DRAWN & DRAFTED BY CHERRY	TOLERANCES		ANGLE: ±1°	TITLE & DESC.: T-H BOBBIN EE-13 (2+5PIN)	
	0<L≤4 ±0.1	pin pitch ±0.2		MAINBODY MATERIAL: PHENOLIC PM9820	
CHECKED & APPROVED BY J.RONG	4<L≤16 ±0.2		SCALE: 1:1	UL REC. UL 94V-0	
	16<L≤63 ±0.3	PIN MATERIAL: CP WIRE		PIN RETENTION LOAD: 1.0 KGF MIN	
			UNIT: MM	INITIAL RELEASE DATE: AUG.30, 2014	DRAWING NO. JT-1308
					PAGE: 1/1

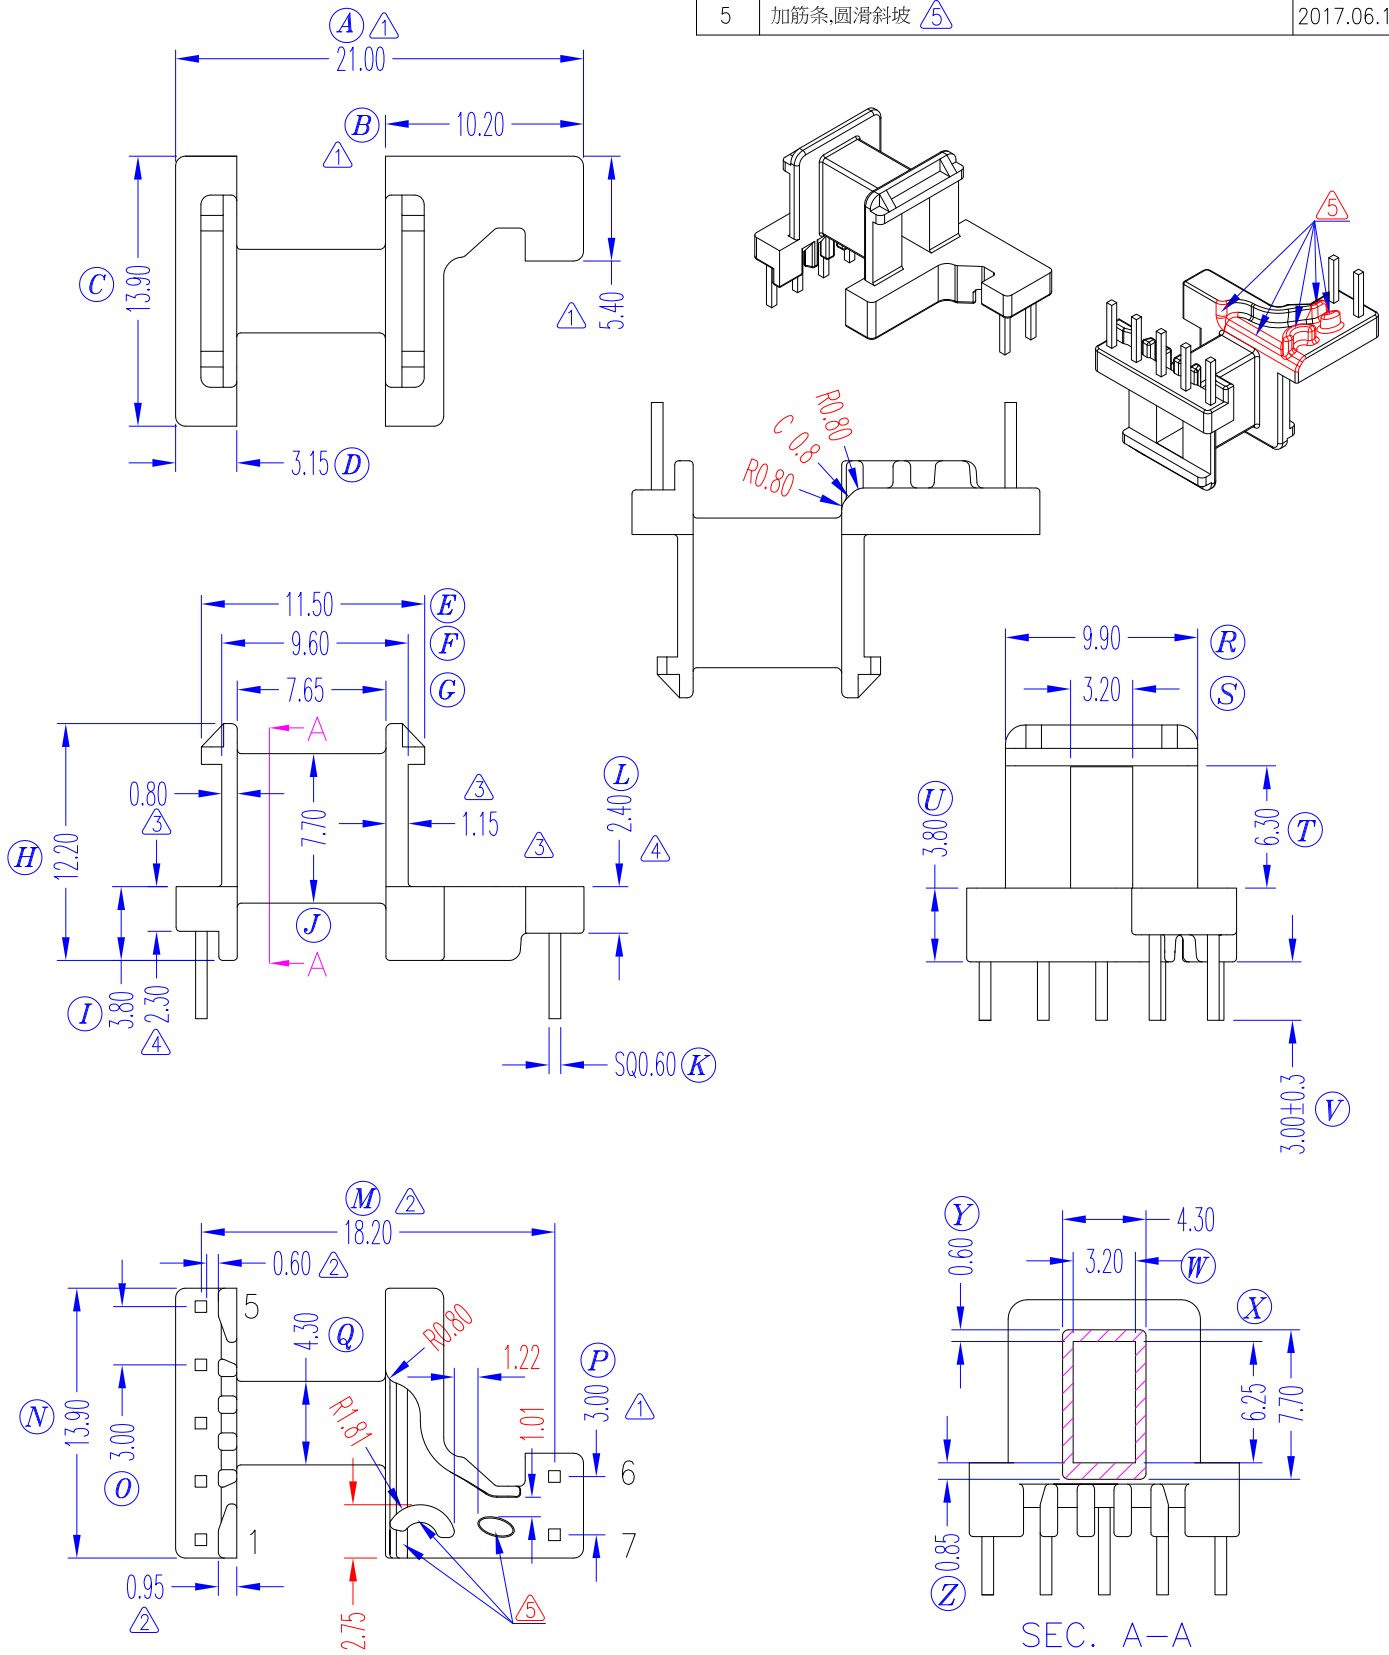
REV.	REVISIONS REC.	DATE
1	变更尺寸, 详见	2014.11.04
2	排距尺寸变更, 描述变更, 详见 , 正式量产发行	2014.11.11
3	SPIN边叶片厚由0.7改为0.8, 2PIN边叶片厚由0.85改为1.15	2015.04.02
4	5PIN台加厚	2015.04.02
5	加筋条, 圆滑斜坡	2017.06.14
